NHTSA Id: 17V-492  
Transport Canada Id: Pending

**SUBJECT:** Utilimaster Corporation, has determined a defect relating to seatbelt mounts on Utilimaster Aeromaster bodies that may exist in certain vehicles.

**CONDITION:** Seatbelt mounts for 8” setback passenger seats were not installed to required specifications.

**APPLIES TO:** This bulletin applies to certain Aeromaster walk-ins manufactured between March 2014 and October 2016 and equipped with 8” setback pedestal seats.

*Overview of D-ring support bracket installation*

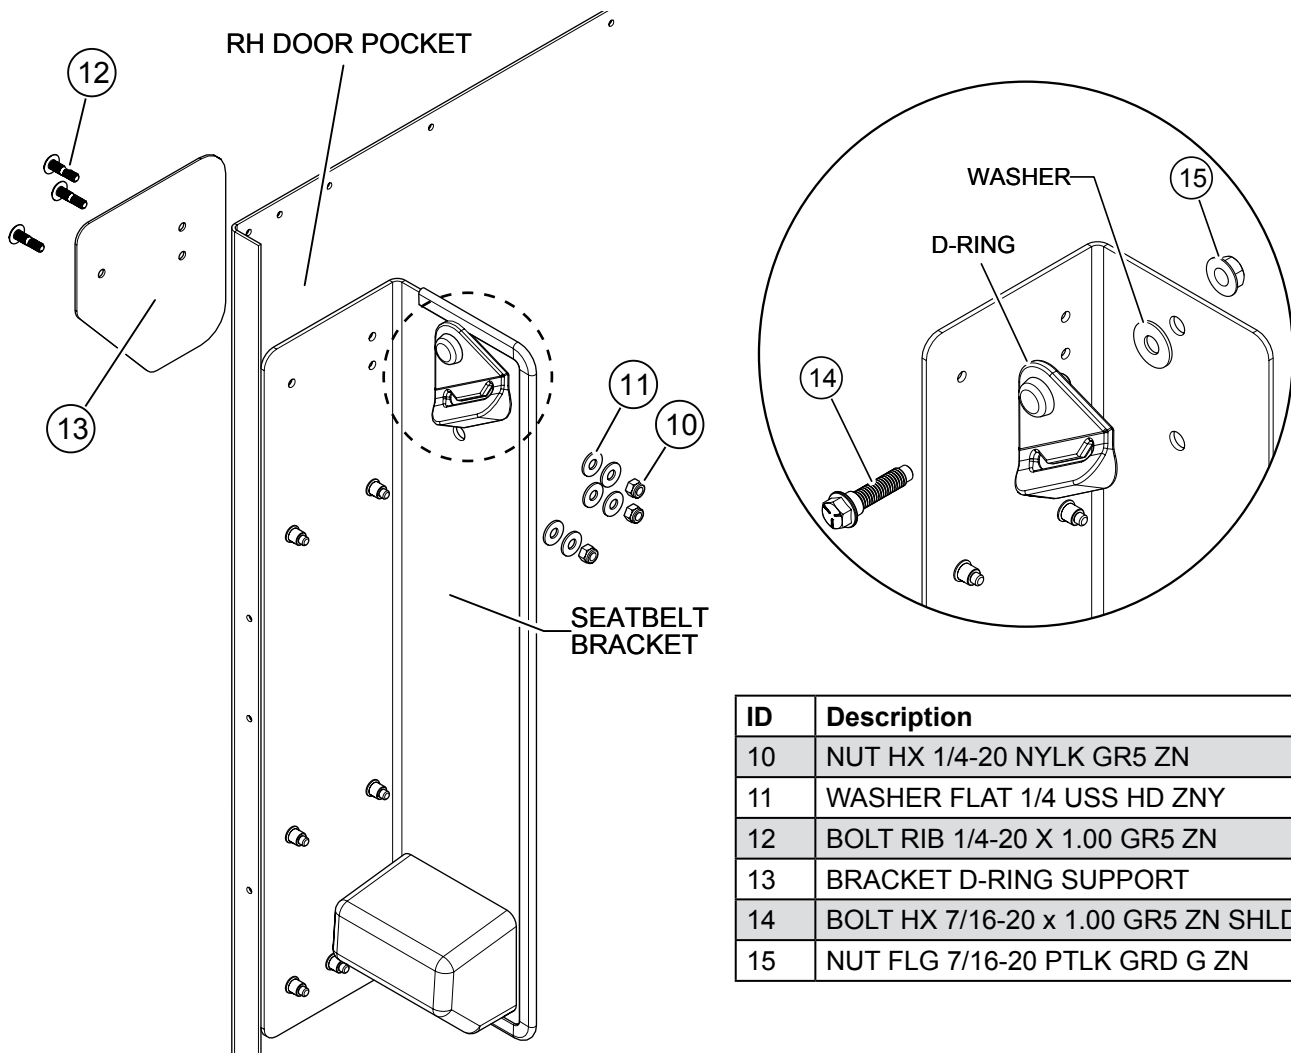
**CORRECTION** Reinforce passenger seatbelt mount with D-ring support bracket.

ID	Description
10	NUT HX 1/4-20 NYLK GR5 ZN
11	WASHER FLAT 1/4 USS HD ZNY
12	BOLT RIB 1/4-20 X 1.00 GR5 ZN
13	BRACKET D-RING SUPPORT
14	BOLT HX 7/16-20 x 1.00 GR5 ZN SHLDR
15	NUT FLG 7/16-20 PTLK GRD G ZN

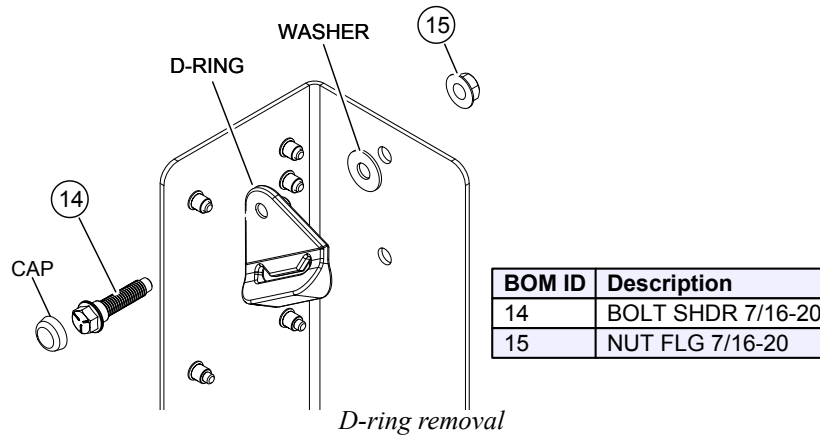
**Replace nut and bolt D-ring fasteners with new hardware. Keep washer for reuse.**

3. Remove D-ring bolt cap and set aside.
4. Remove 7/16-20 fasteners from D-ring and discard. Set aside D-ring and washer for reuse.

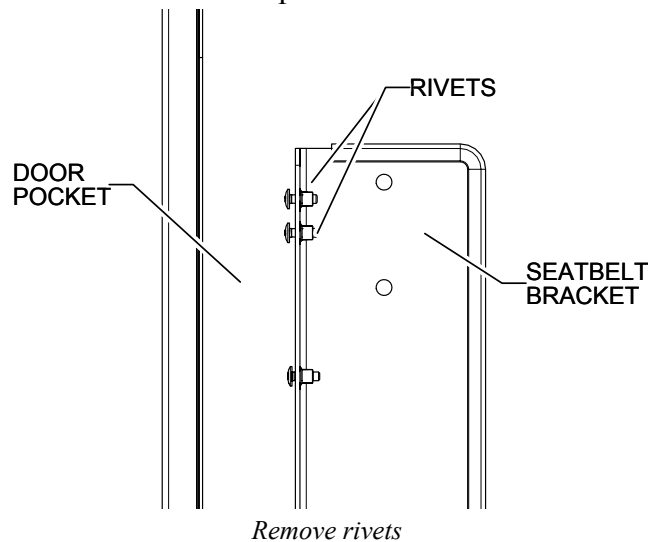
**Do NOT let rivet heads fall into door track or door pocket.**

6. Use a 7/32" bit to drill out (3) pin-and-collar rivets securing seatbelt bracket. Use a center punch to knock out rivets in bracket. Remove tape.

*D-ring support bracket fasteners*

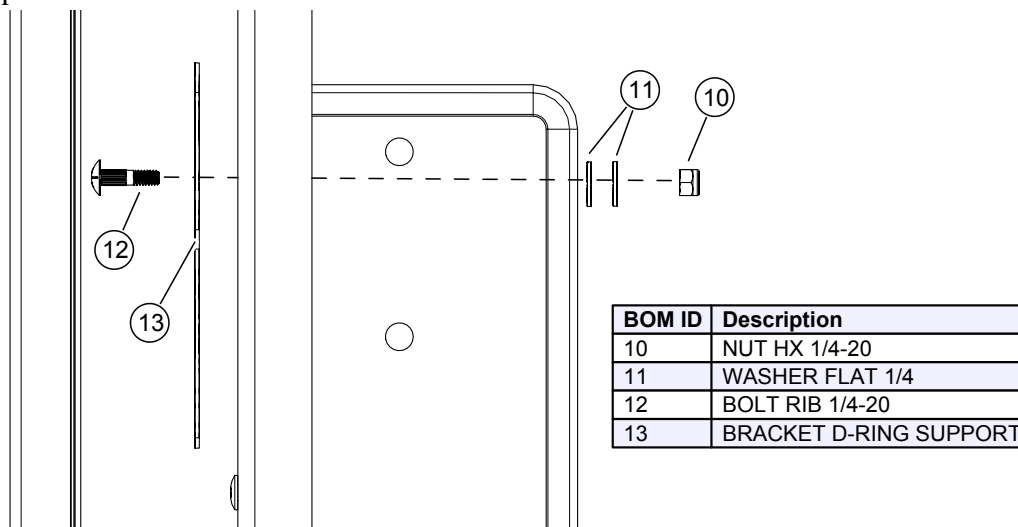
*Reuse original washer with new D-ring fasteners.*

7. Align support bracket with existing holes in door pocket and hand tighten (3) 1/4-20 rib bolts with (6) washers and (3) lock nuts.
8. Tighten nuts to pull rib bolts flush with D-ring support bracket.
9. Torque nuts to 7–9 ft•lbs.

10. Secure D-ring to seatbelt bracket using replacement 7/16-20 bolt and nut.
11. Torque nut to 32–49 ft•lb.
